Re: Tract N-1-B Watershed Subdivison - Sketch Plat Submittal

PLAT OF
TRACTS N-1-A & N-1-B
WATERSHED SUBDIVISION
(A REPLAT OF TRACT N-1,
WATERSHED SUBDIVISION)
PROJECTED SECTIONS 17 AND 18,
TOWNSHIP 10 NORTH, RANGE 2 EAST,
N.M.P.M.
ALBUQUERQUE,
BERNALILLO COUNTY, NEW MEXICO
AUGUST, 2023

REQUEST: Sketch Plat review for Tract N-1-B Watershed
IDO -2022

Development Facilitation Team (DFT) – Review Comments

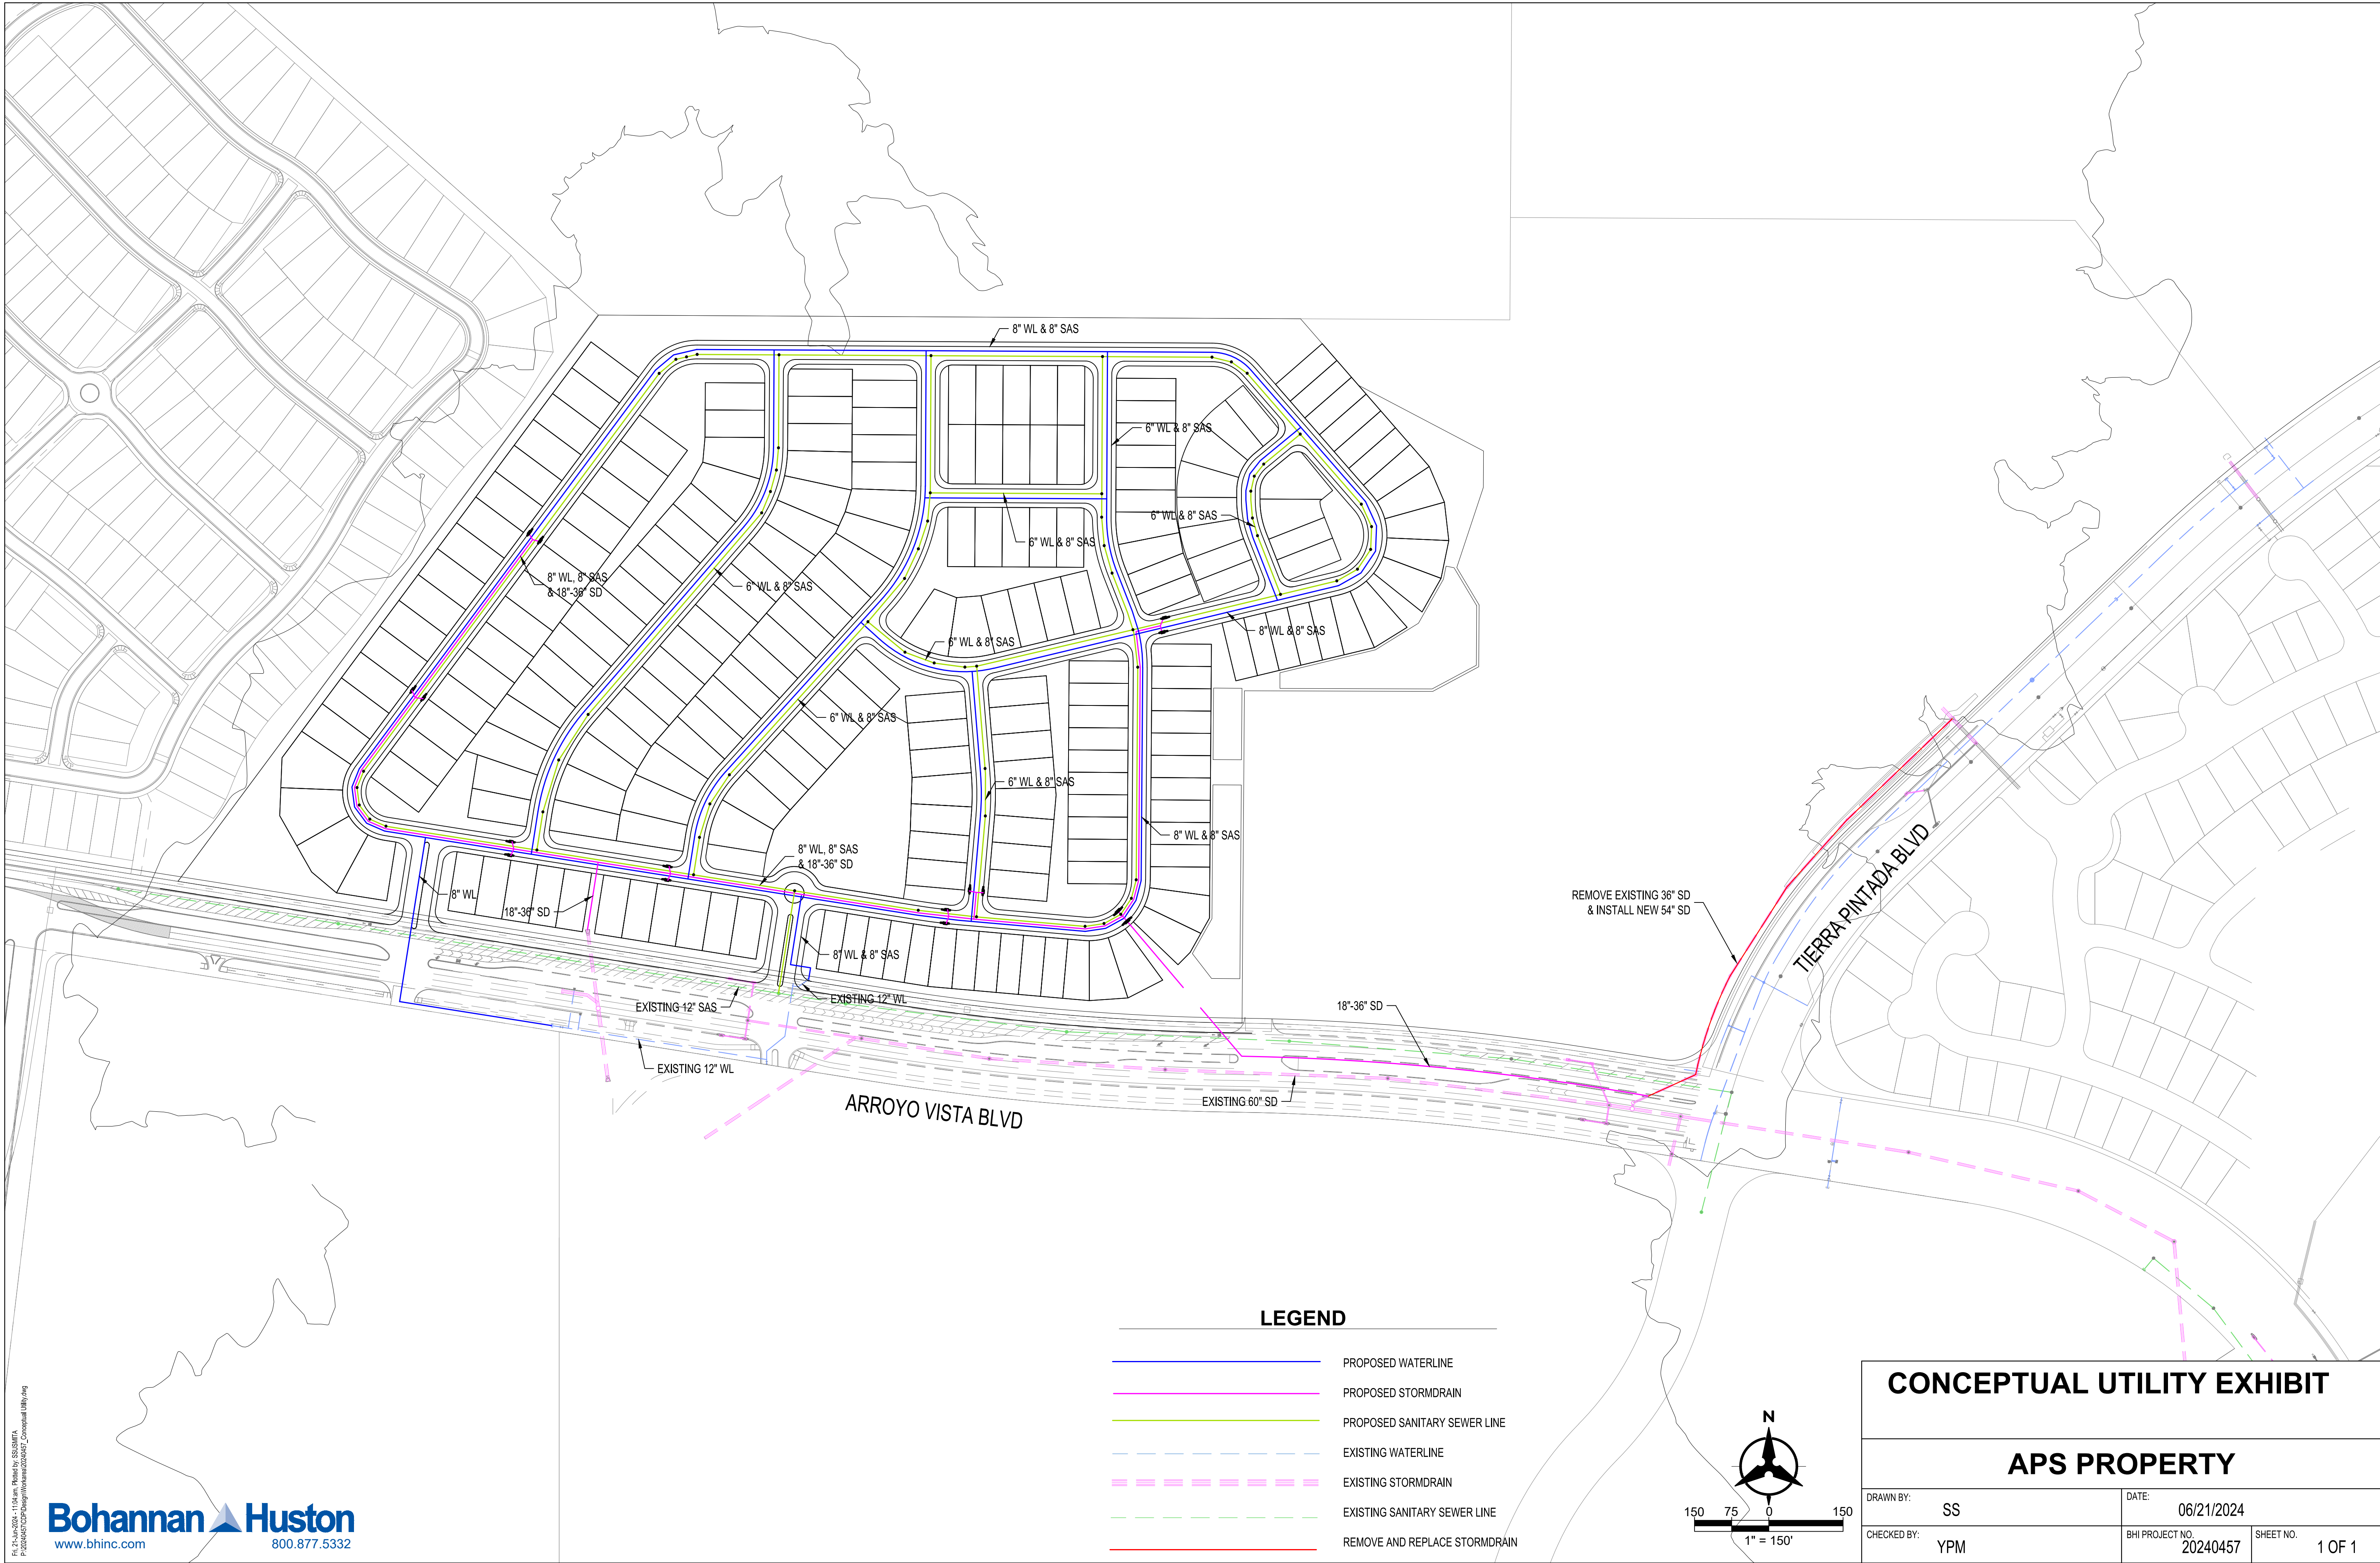
1. Request an availability/serviceability statement online at the following link:
http://www.abcwua.org/Availability_Statements.aspx. Requests shall include fire marshal requirements. An executed statement must be obtained prior to approval.
2. Regarding the comment for water, please provide a maximum pad elevation for the site to determine if there is any need for 5W infrastructure.
 - a. Note that the highest contour I see for the site based on our mapping system is right at the 5W/4W pressure zone boundary at 5485 feet which is evident the entire site currently sits within the 4W pressure zone thus not requiring a PRV to provide pressure to the site.
3. As proposed the site is on a really long dead end line and will require some sort of loop. Perhaps to the adjacent site on APS site which will create a good looped water system to provide redundancy for the future development.

1. Arroyo Vista is a Principal Arterial and requires a 6' sidewalks with a 5' to 6' landscape buffer. There is an existing multiuse trail along here which meets sidewalk requirements.
2. All internal roads would be local roads and require 5' sidewalk with a 4' to 6' landscape buffer.
3. Prior to site plan an approved TCL is required. Also, please submit a Traffic Scoping Form to Curtis Cherne (ccherne@cabq.gov) to determine if a TIS is required.

- Hydrology will need to approve a Conceptual Grading & Drainage Plan prior to platting.
- The infrastructure list will be needed for Preliminary Plat.
- Hydrology will also need AMAFCA's approval prior to plat approval.

It is noted that a single-loaded street has been placed on the edge of the subdivision adjacent to Petroglyph National Monument which meets of the requirements of 5-2(J).

It would appear that you have been able to keep some block lengths under 600 feet, but some are not.
